United States Patent and Trademark Office

| APPLICATION NO. | FILING DATE | FIRST NAMED INVENTOR | ATTORNEY DOCKET NO. | CONFIRMATION NO. |
|---|----------------------|----------------------|-----------------------|------------------|
| 10/606,008 | 06/25/2003 | Bernd Schessl | 2000P13034WOUS | 5730 |

DETAILED ACTION

Fig. 1

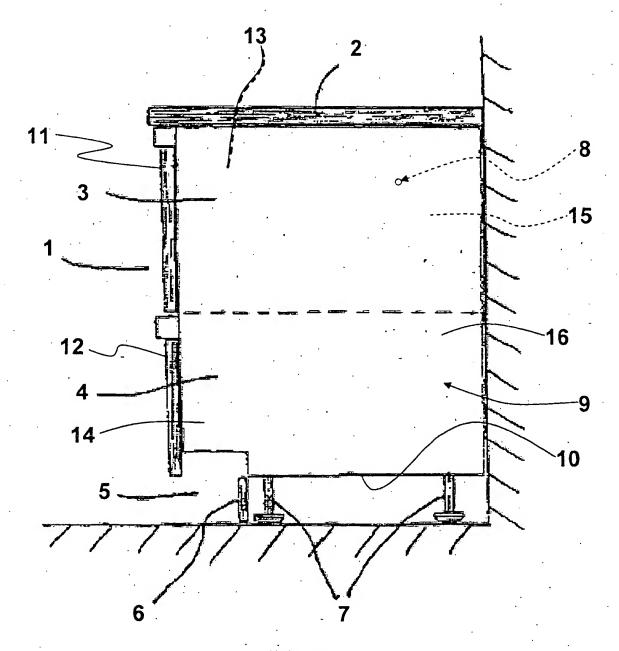
2. The proposed replacement sheet of Figure 1 was received on March 27, 2007. At this time, the examiner has not approved the replacement sheet since it appears that the leader line for reference #13 should be dotted as is the case for the leader lines of reference #'s 8 & 15.
